SERVICETEKNOTES

Published by Tektronix
Service Publications

TABLE OF CONTENTS

Fig. 3-17. Black Burst.

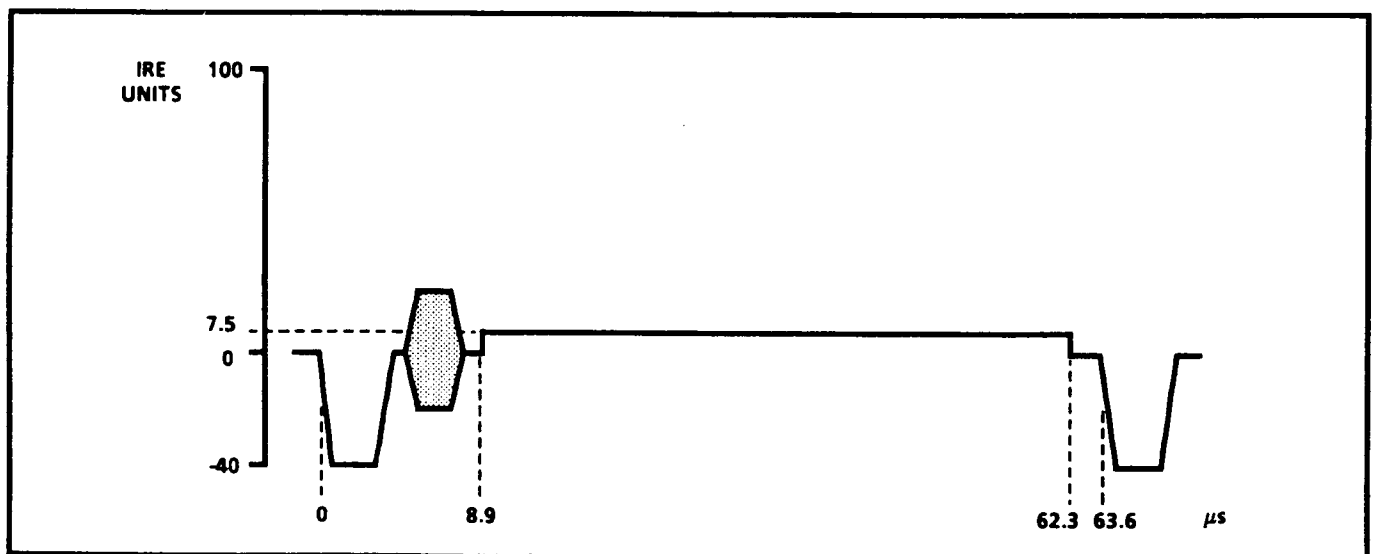
Page 3-14, Fig. 3-17. Black Burst
CHANGE Fig. 3-17 AS SHOWN:

Page 4-2, Fig. 4-1 Black Burst Line Timing

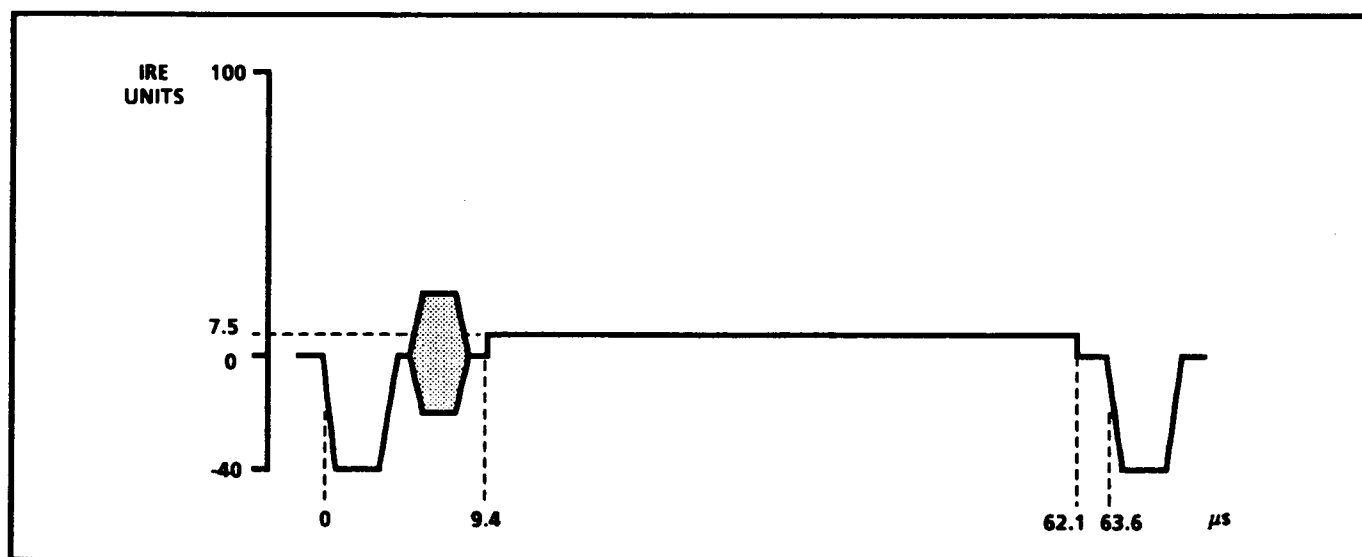
CHANGE Fig. 4-1 **AS SHOWN:**

Fig. 4-3. SMPTE BARS detail.

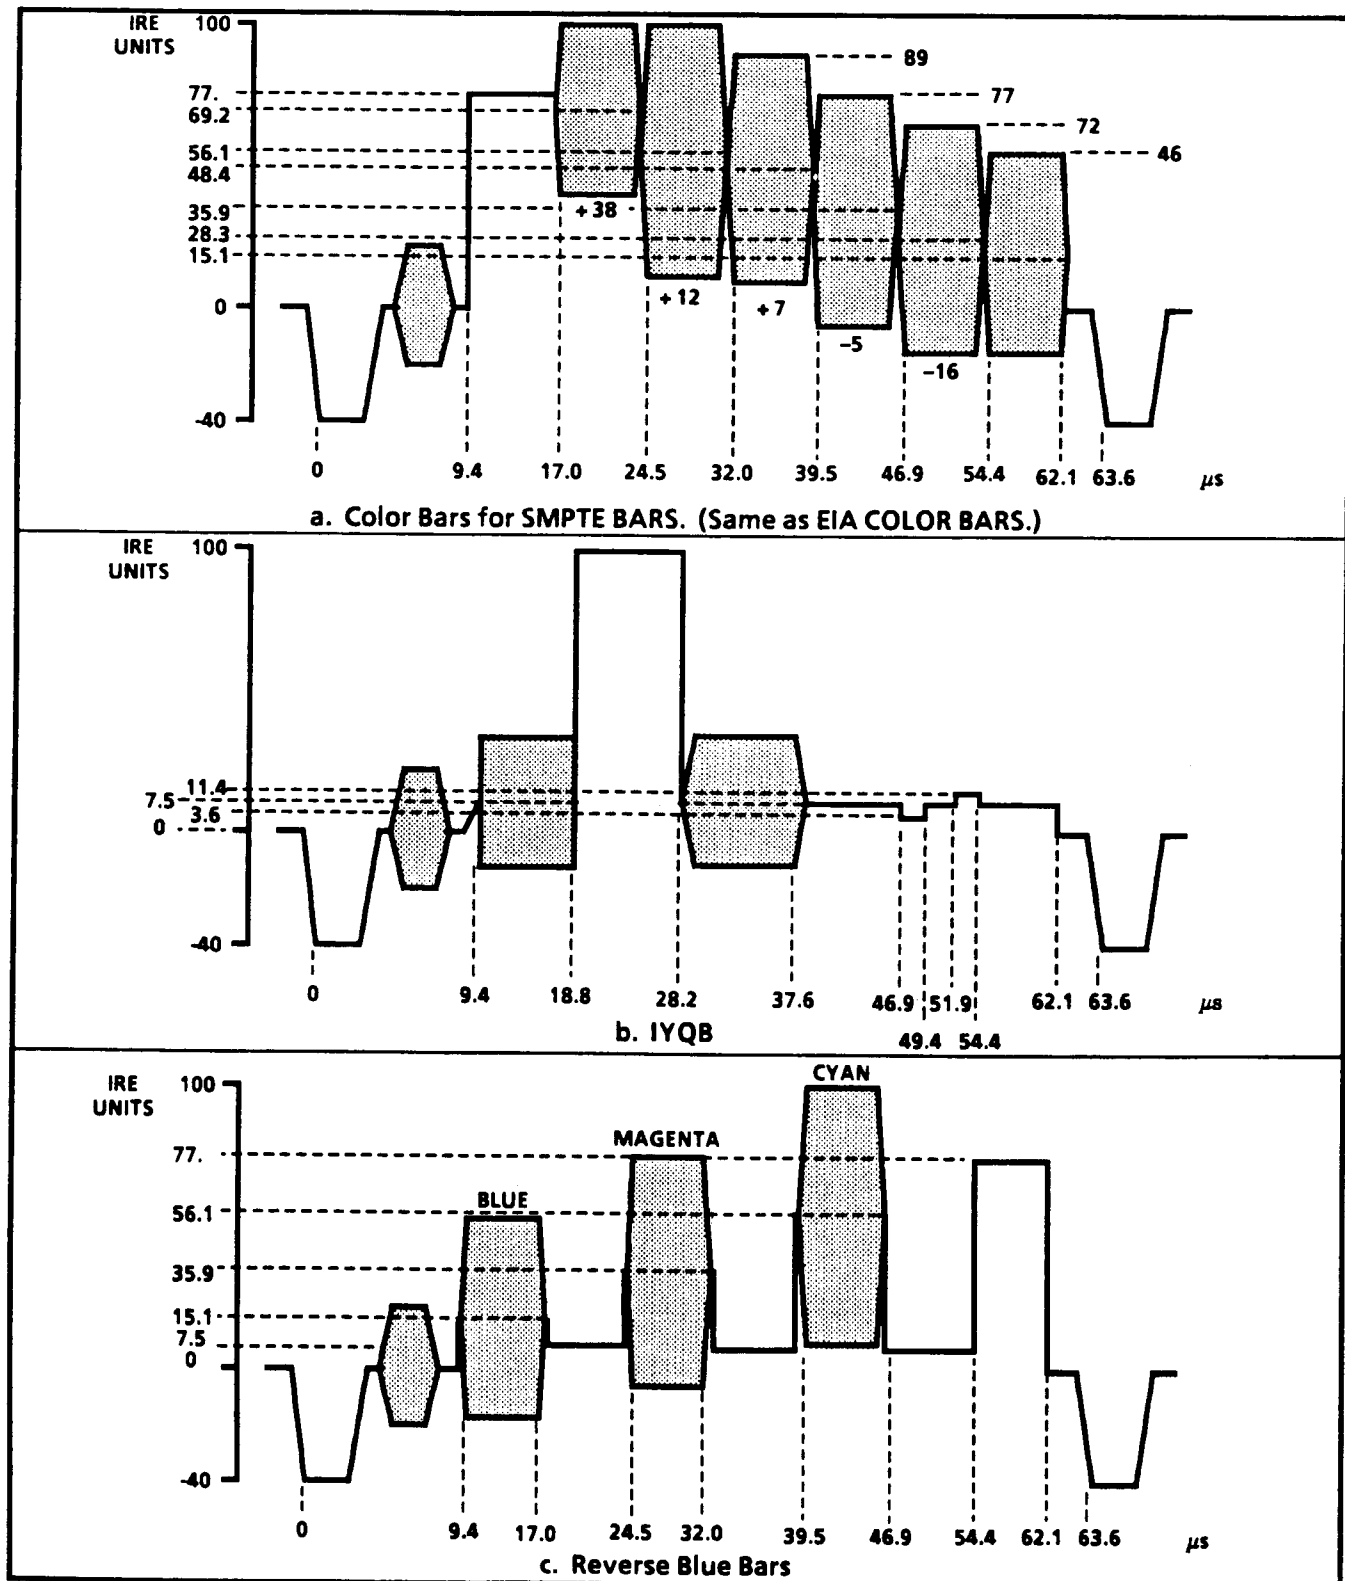
CHANGE Fig. 4-3 AS SHOWN:
